Issue Date: August 21, 2020

TO BIDDERS ON: HIGHLAND HOSPITAL KORET Building Exhaust Fan and Waterproofing
1131 East 31st Street
Oakland, California

END OF ADDENDUM NO. 02

E1.0

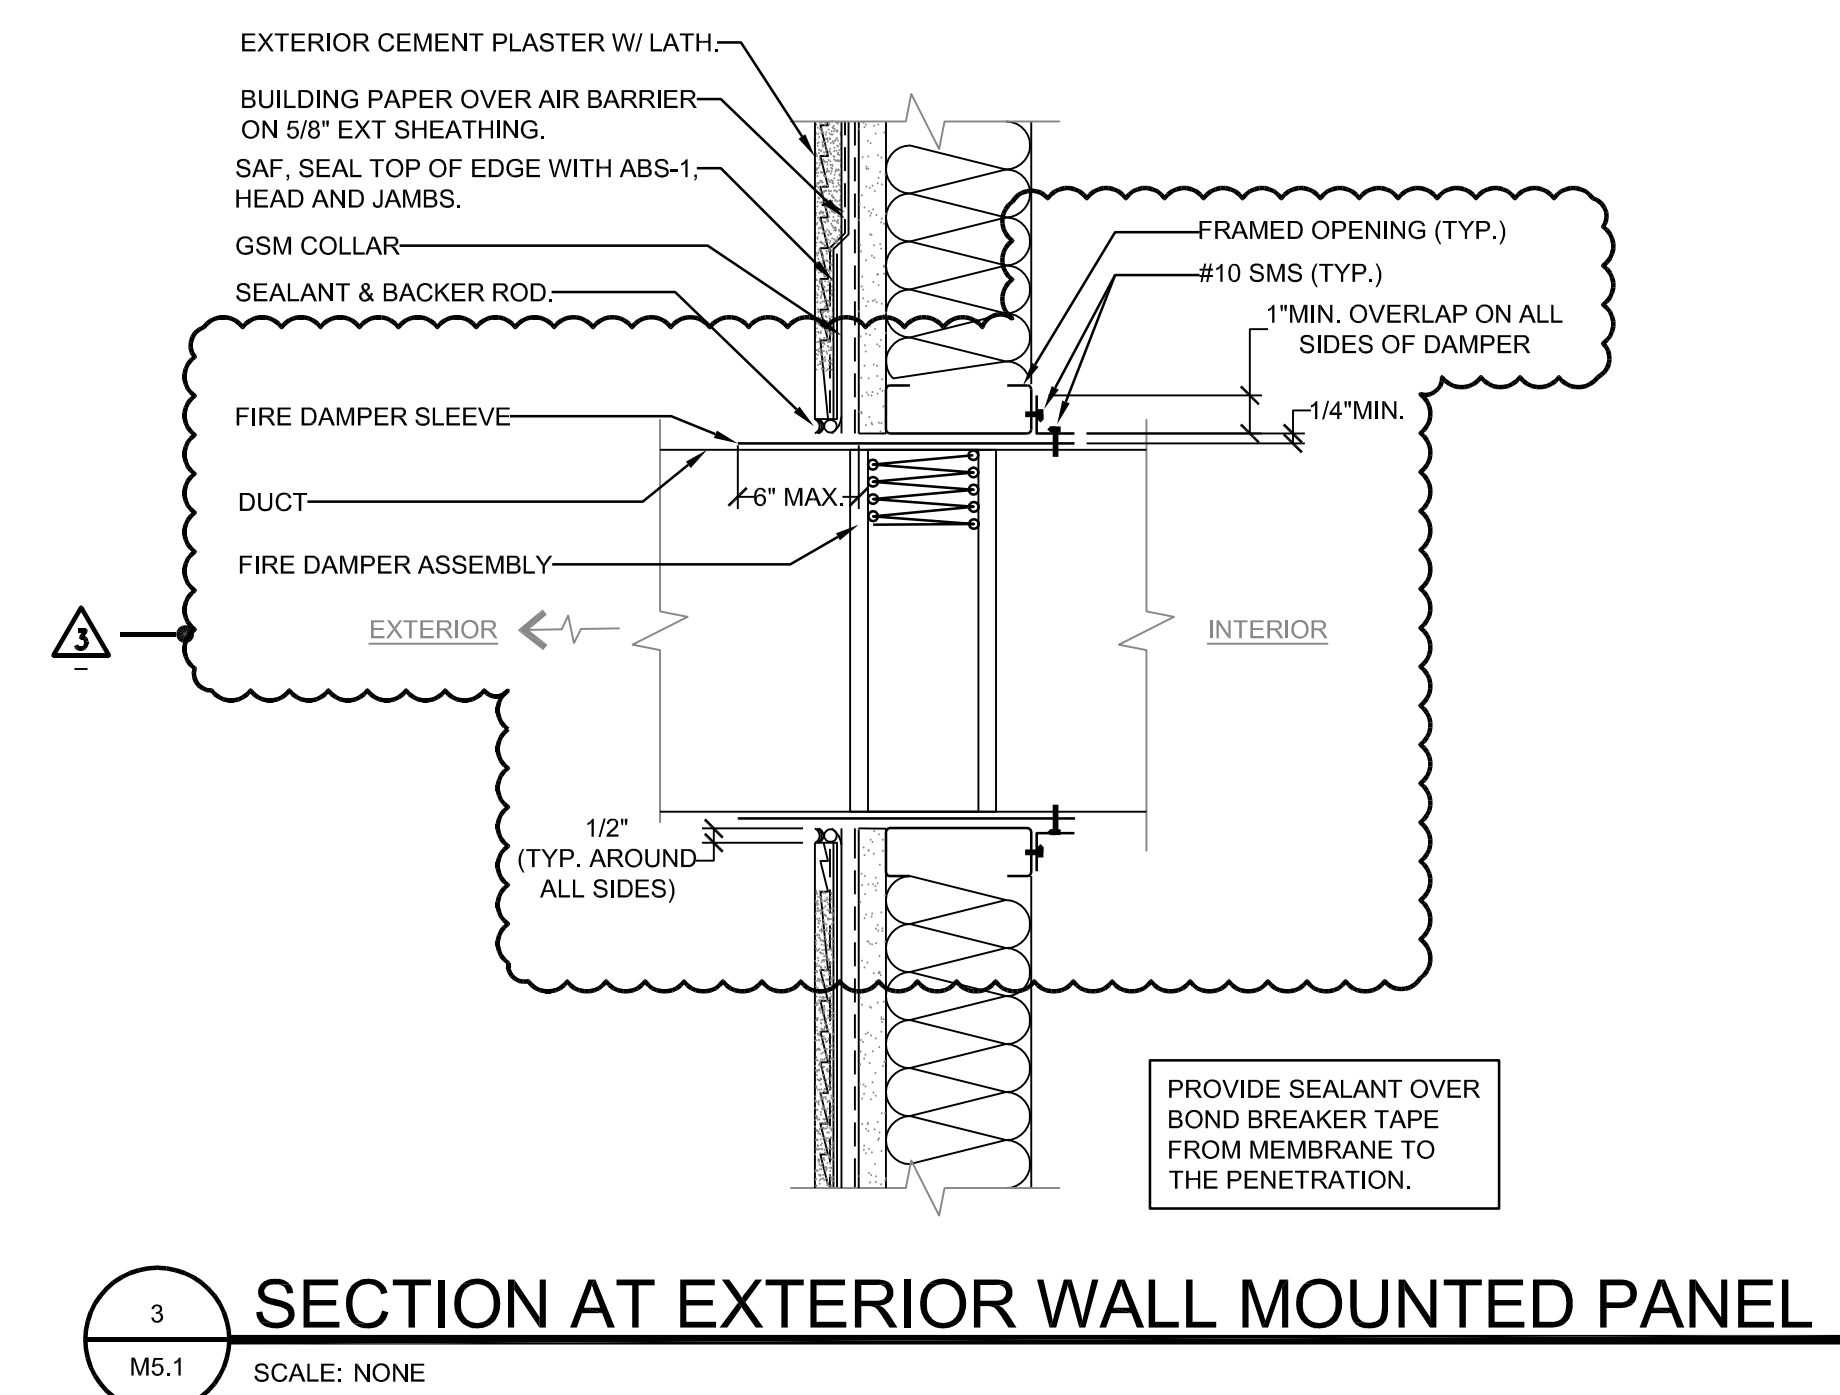
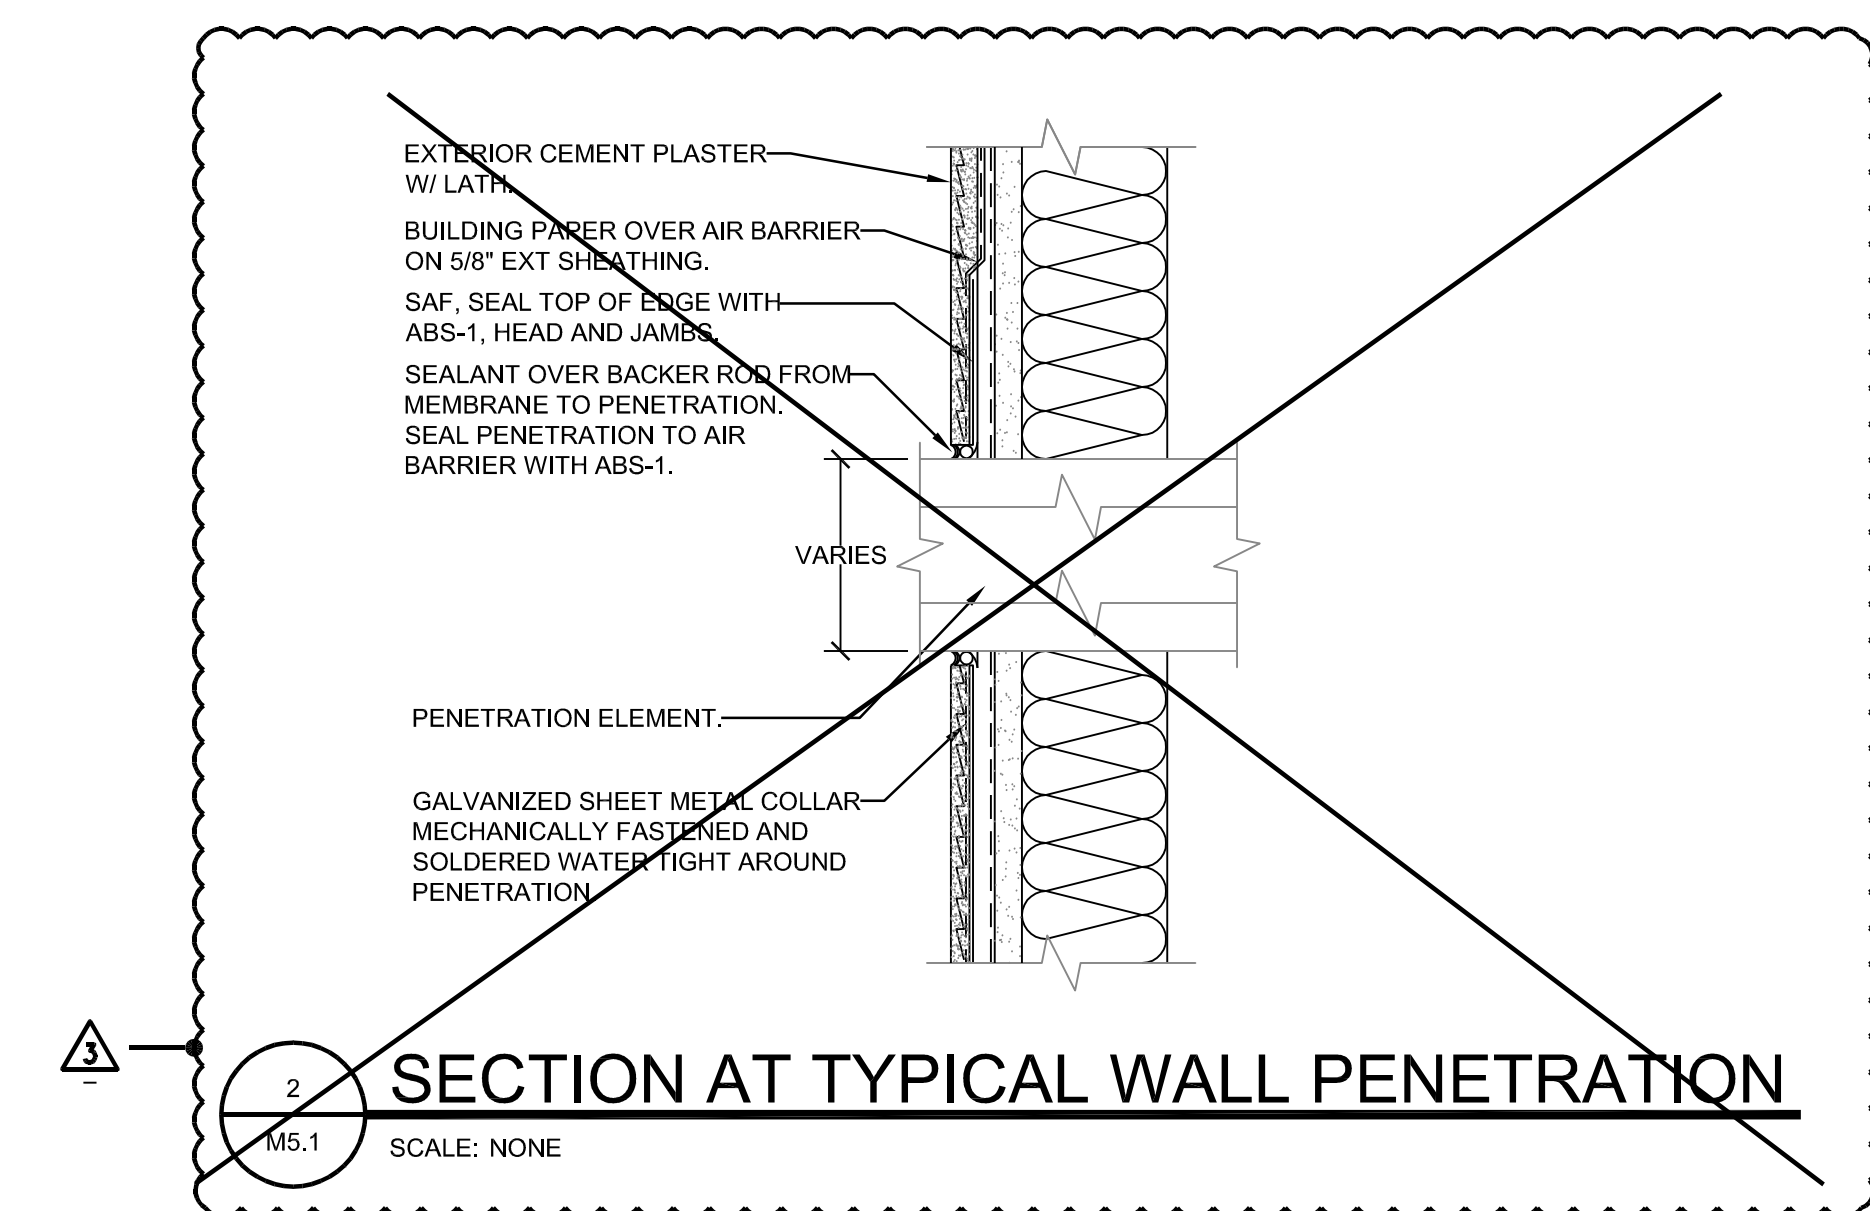
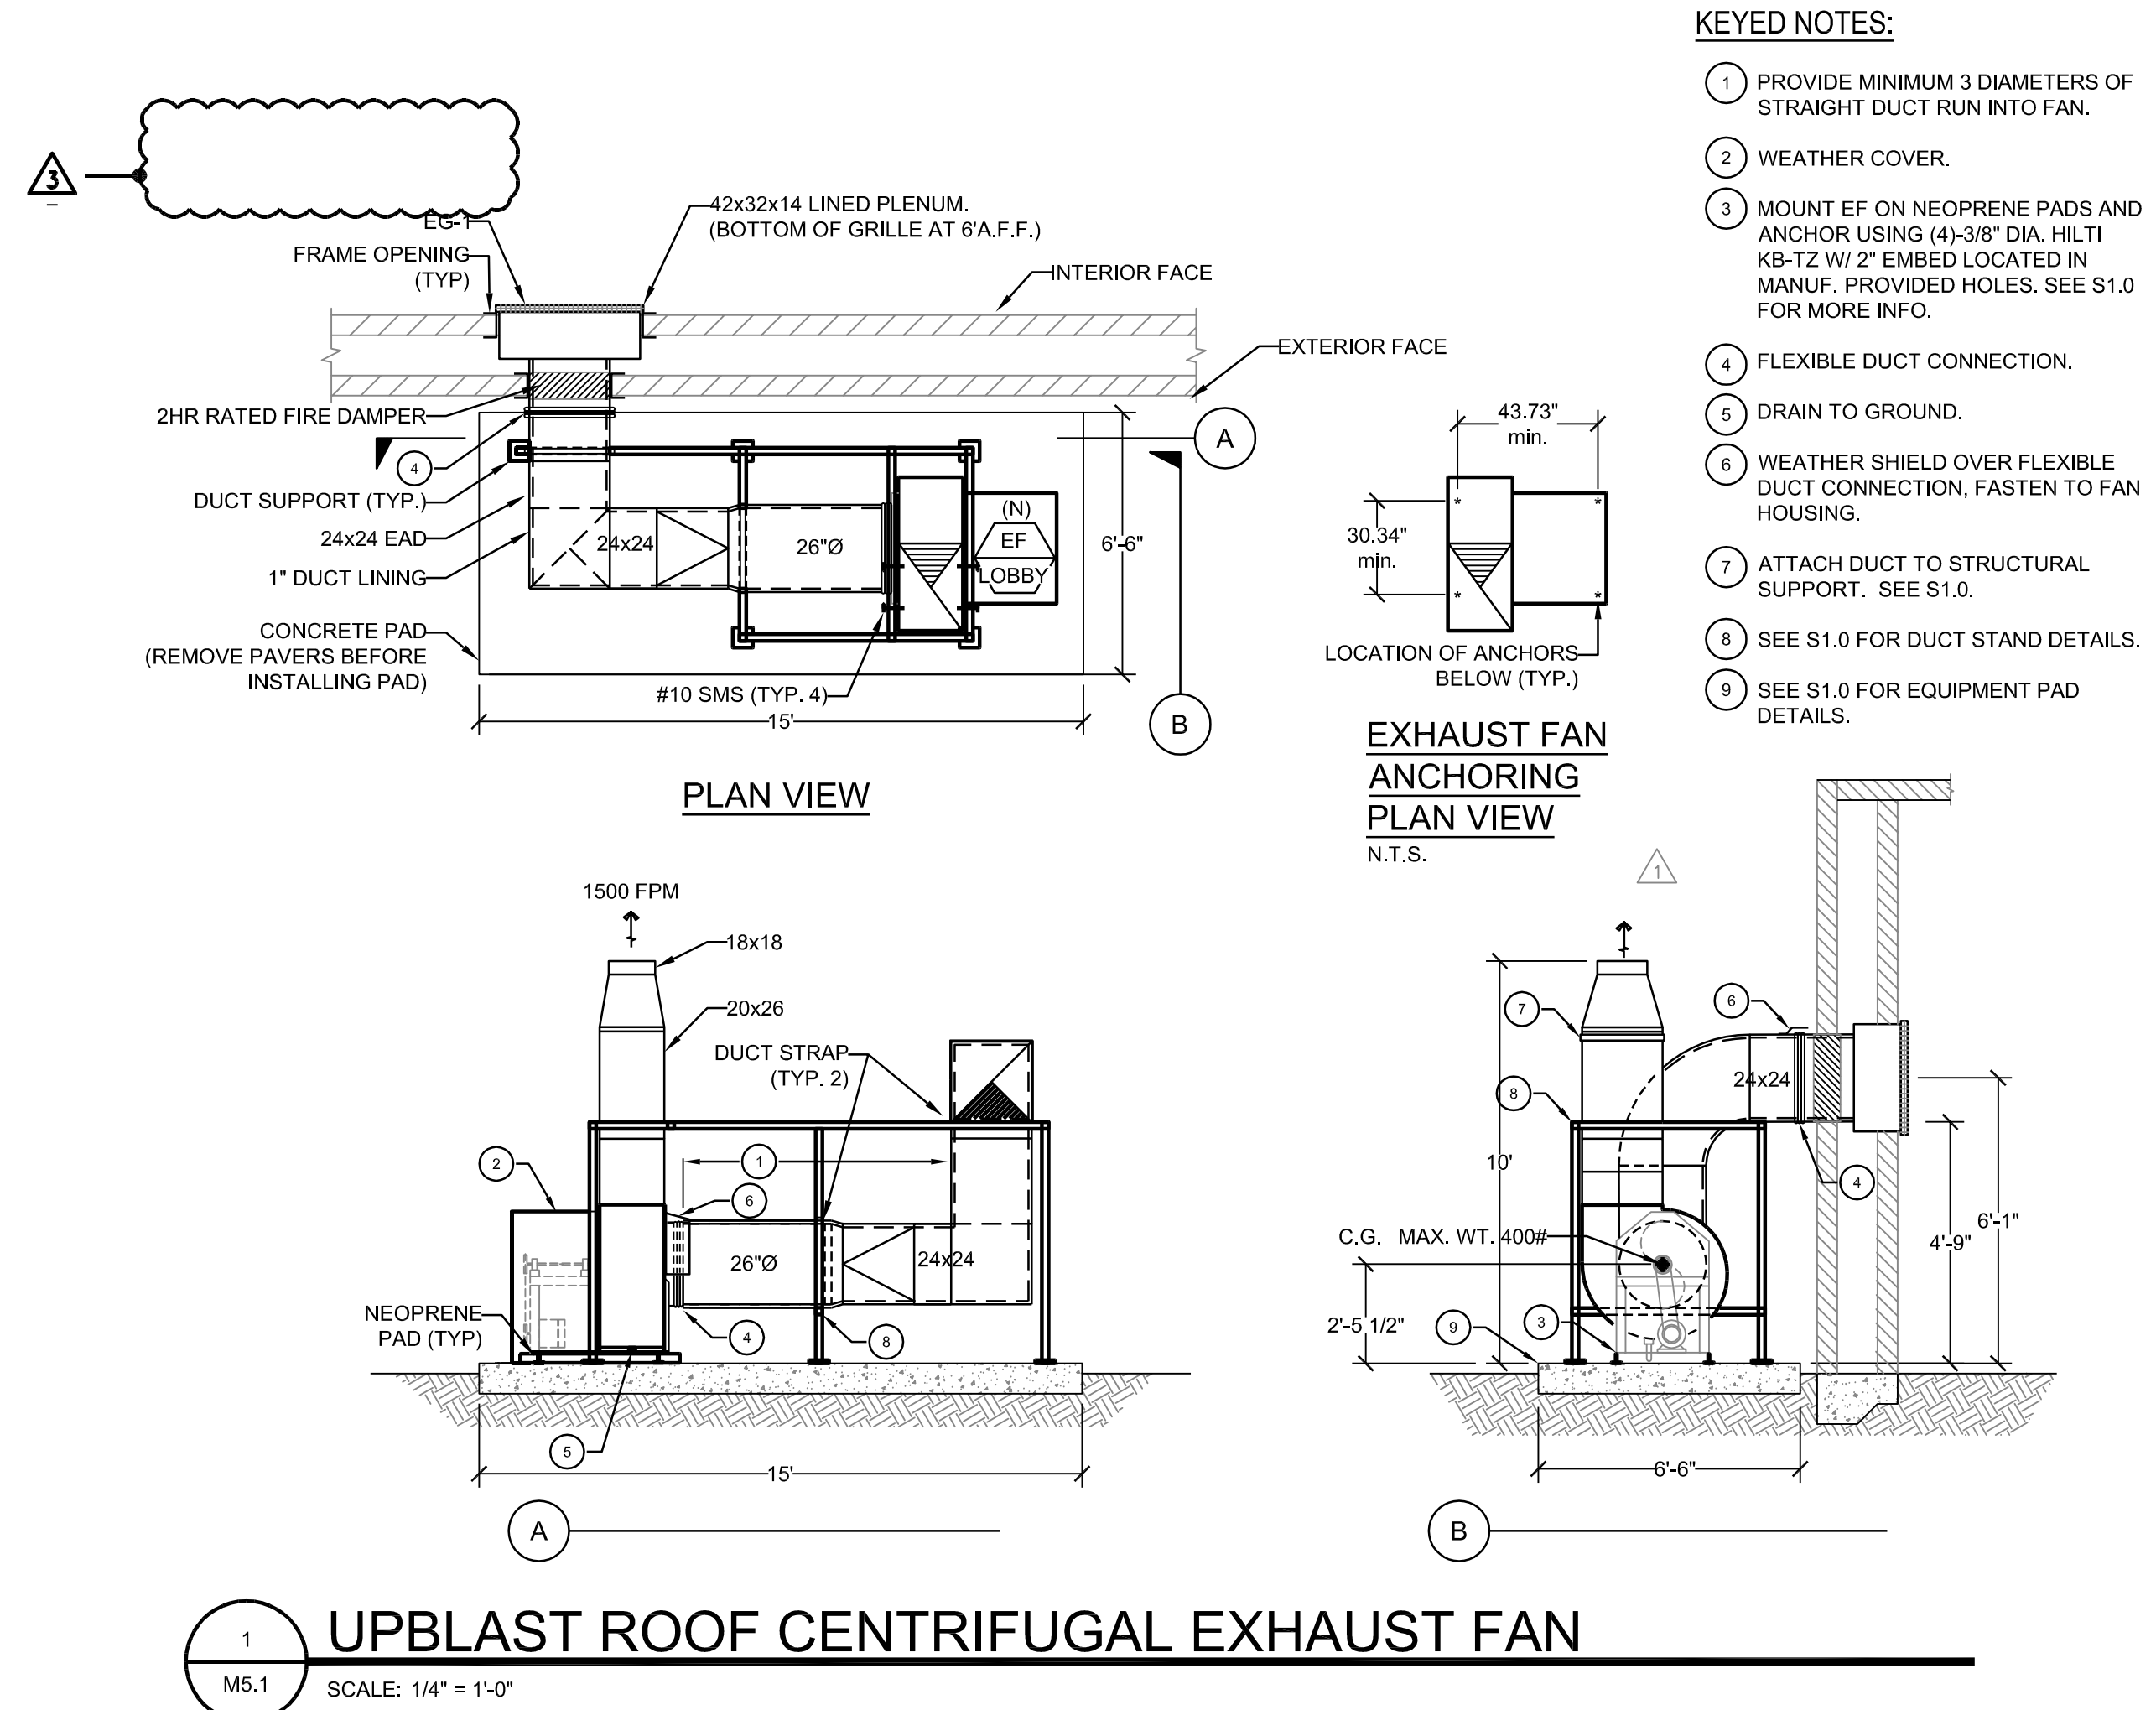
1. Please show on a drawing the path of travel for the electrical for the new exhaust fan (from the exhaust fan to the electrical panel) for the Highland Hospital Koret Building Exhaust Fan Project. I understand from my mechanical contractors that it is about 200 ln. ft. in length. Is this going overhead in the ceiling or below under the floor? Off hours?

Response: Please refer to E-10 – ACD showing a reference drawing between the area of work and the electrical panel. The path of travel for the exhaust fan electrical is the contractor means and methods. Work to be scheduled with the Facility Administrator. In addition contractors will submit an MOP (Methods Of Procedure) and approved by the Facility Administrator before start of work. Electrical work (pathway and wiring) will be performed from 6:00 PM - 6:00 AM because the pharmacy is open at 8:00AM - 5:00 PM

① THE LEVEL TWO PANEL, ITS FEEDER AND FEEDER OVERCURRENT PROTECTING DEVICE HAVE BEEN CHECKED AND IT HAS BEEN DETERMINED THAT SUFFICIENT LOAD CAPACITY EXISTS AT THIS POINT IN THE ELECTRICAL DISTRIBUTION SYSTEM. CONTRACTOR SHALL PERFORM 3-DAY LOAD READING BEFORE CONNECTING NEW LOAD, AND PROVIDE RESULTS TO E.O.R.
